DEVELOPMENT REVIEW BOARD
SUPPLEMENTAL SUBMITTAL

PROJECT NO. PR-2022-007875
Application No. SI-2022-02109-SITE PLAN

SUBMITTAL DESCRIPTION: Revised Site Plan, Landscape Plan Infrastructure List and Deviation Justification

Project: Kimmick & Rosa Parks

Option 4: Overhang Cap

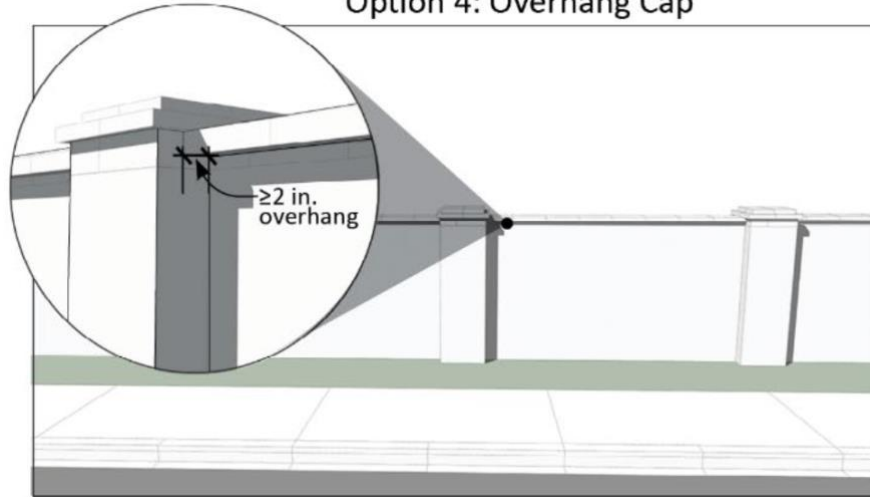
COMMENT #13

Locate and design all walls, fences, retaining walls, and combinations of those site features facing the Major Public Open Space in compliance with all applicable standards in Section 14-16-5-7(E)(4) (Walls Adjacent to Major Arroyos or Major Public Open Space).

Design consideration has been made to ensure compliance to the standards outlined in Section 14-16-5-7(E). Garden walls will be constructed of CMU block and coated with stucco. No wall will be higher than the 6' maximum height restriction. Community walls facing public roadways and Major Public Open Space will be constructed of CMU block with an overhang top cap.

Sheet Title:
Landscape Plan

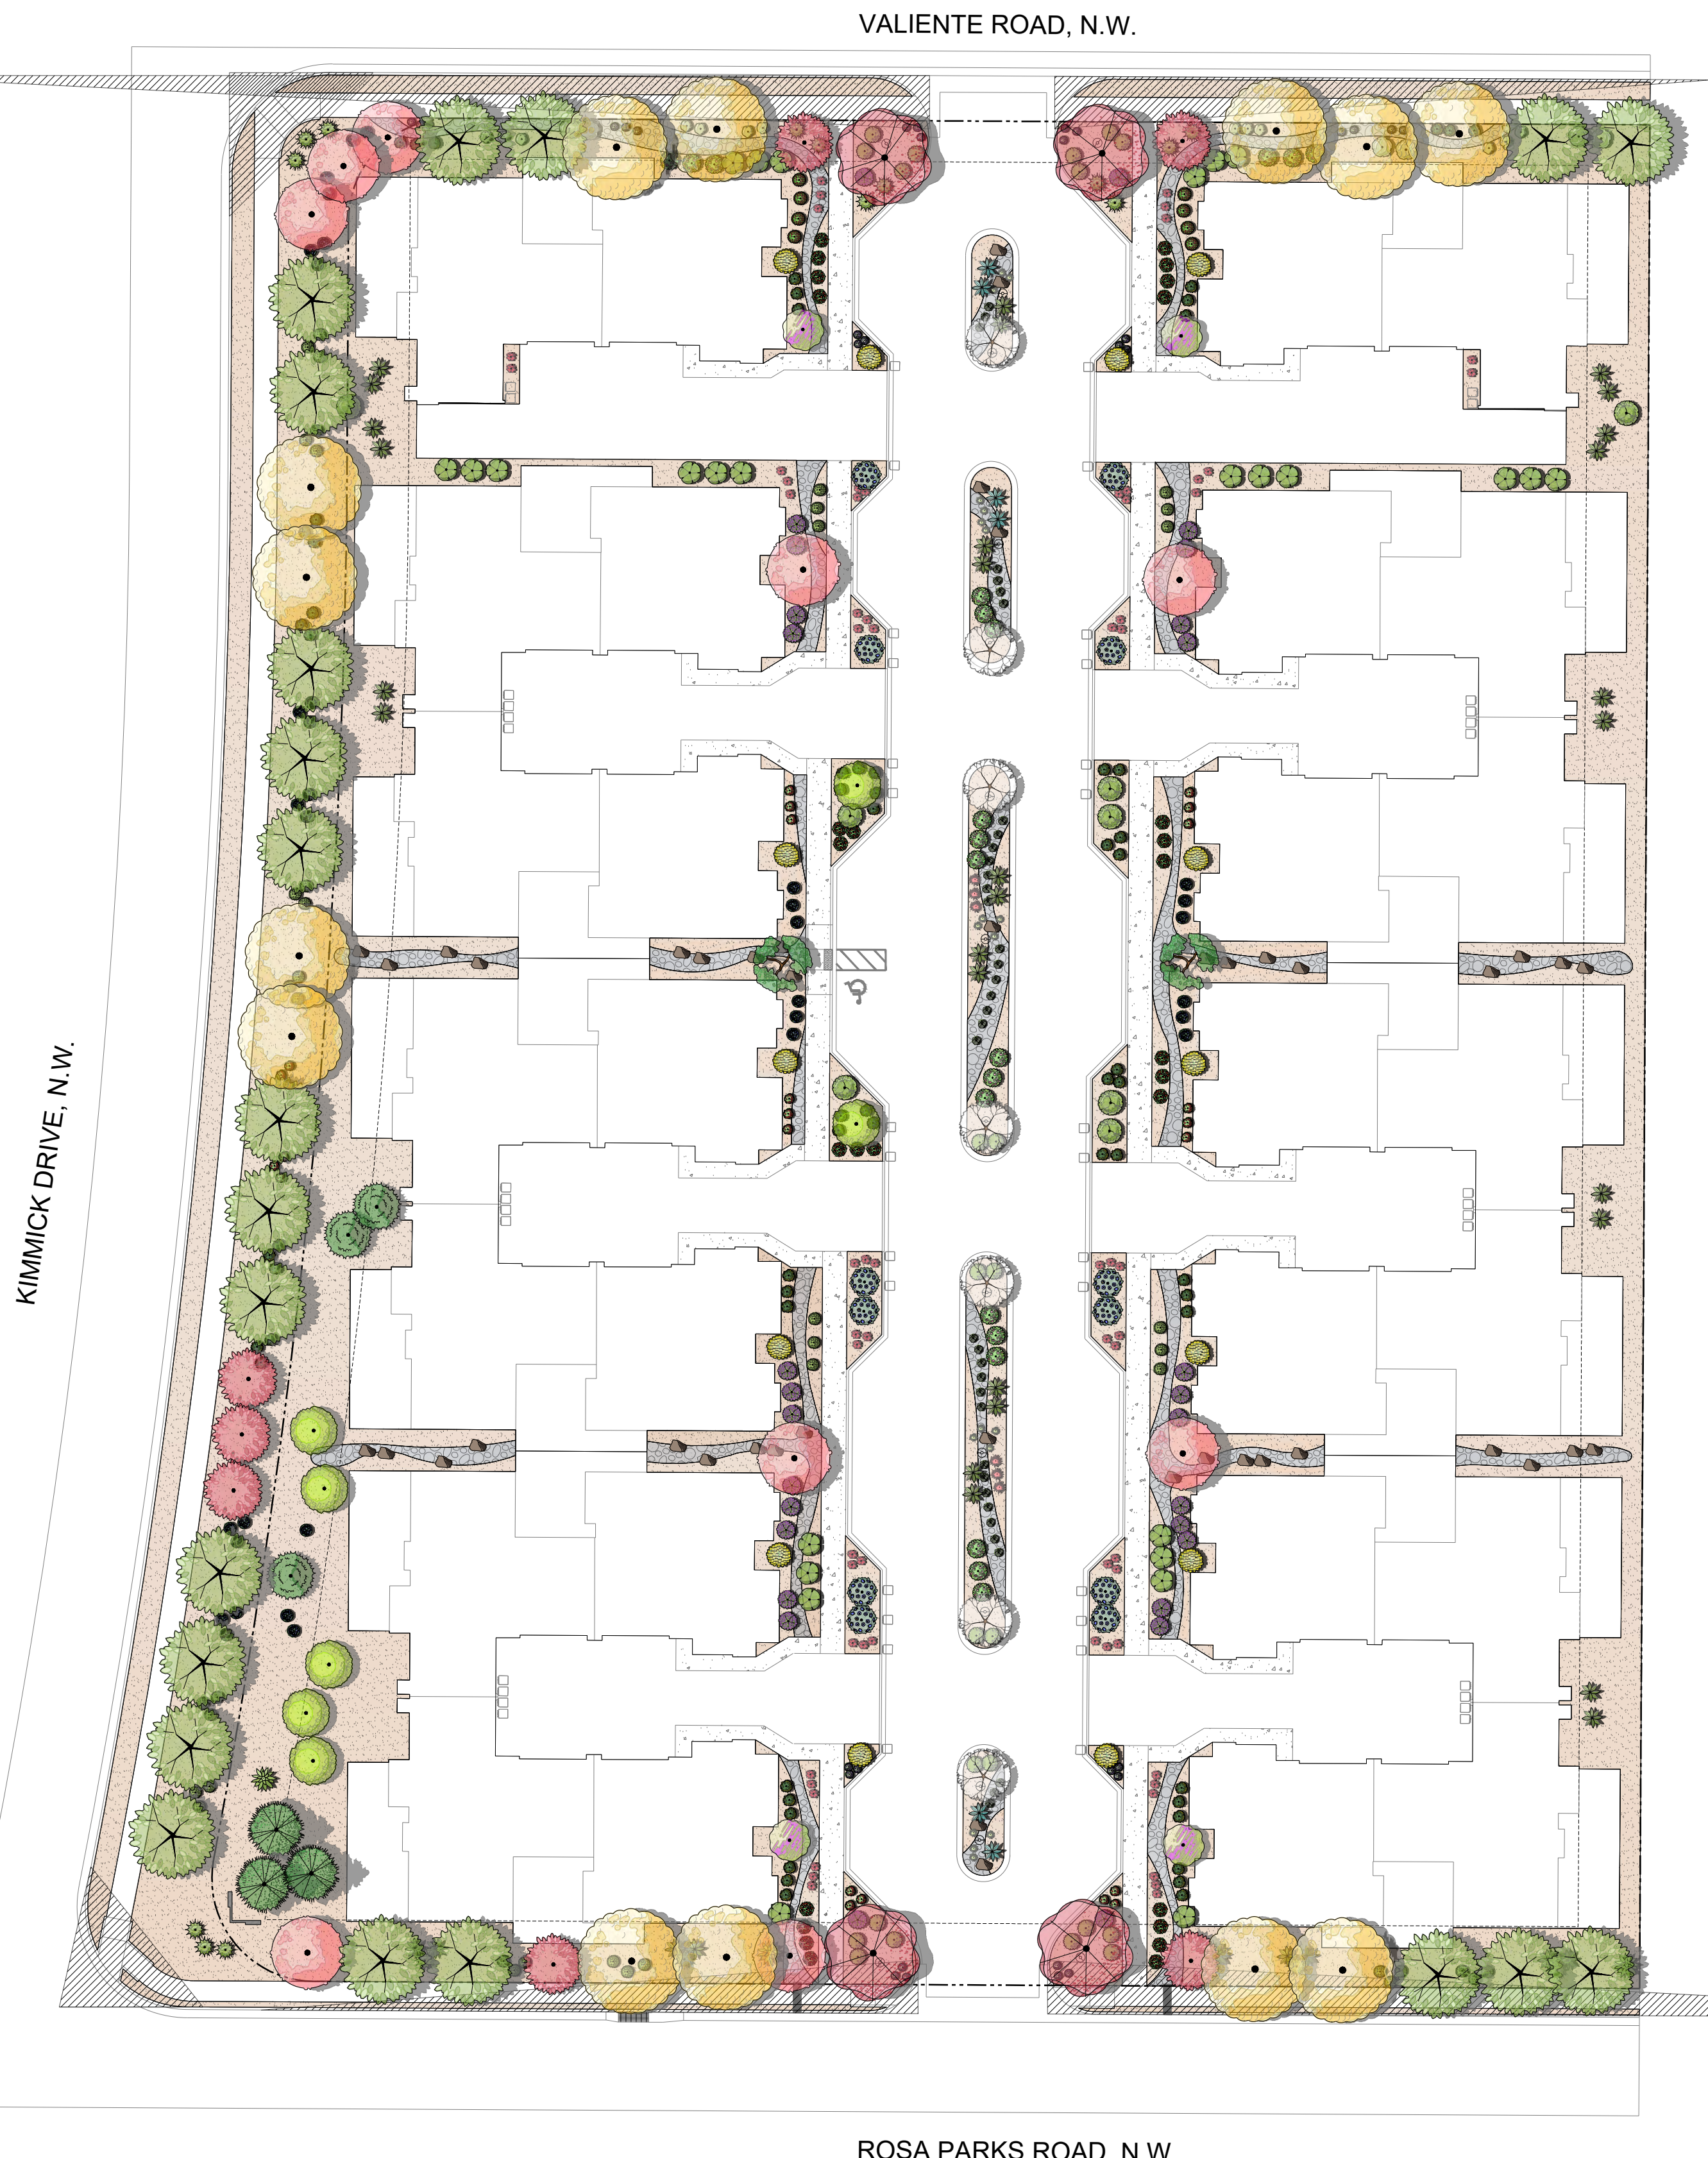
COMMENT #4**5-2(J)(1)(b) Landscaping, Buffering, and Screening**

- 1. Use native and/or naturalized vegetation for landscaping materials.*
- 2. Screen mechanical equipment pursuant to Subsection 14-16-5-6(G) (Screening of Mechanical Equipment and Support Areas).5-2(J)(1)(c) Outdoor Lighting Design lighting pursuant to Section 14-16-5-8 (Outdoor and Site Lighting).*

COMMENT #6

5-2(J)(1)(e) Signs

1. *Electronic signs are prohibited pursuant to Subsection 14-16-5-12(H)(2)(e).*
2. *Signage shall be located to minimize visibility from Major Public Open Space and designed pursuant to Subsection 14-16-5-12(E)(5) (Illumination and Motion).*

- 1. A landscape plan is included with this submission. All planned landscaping will be naturalized vegetation for landscaping materials.*
- 2. Design consideration has been made to ensure that all mechanical equipment will be screened from view per subsection 14-16-5-6(G). All mechanical equipment will be roof mounted and screened by parapet walls.*
- 3. Design consideration has been made to accommodate restrictions pursuant to 14-16-5-8. All exterior lighting will comply with New Mexico Night Sky Protection Act. No lighting poles will exceed 20' in overall height per 5-8(D)(3). All outdoor light fixtures mounted to the buildings will be mounted at least 6 feet above ground and no more than 15 feet above ground. Please see building elevation renderings to see proposed locations of exterior building mounted lighting elements.*

No electronic signage is being proposed in relation to this project. Design consideration has been made to minimize visibility from MPOS. The only signage being proposed is monumentation at the northwest and southwest corners of the property. Specific location and sizing of signage monumentation is shown on the landscaping plan.
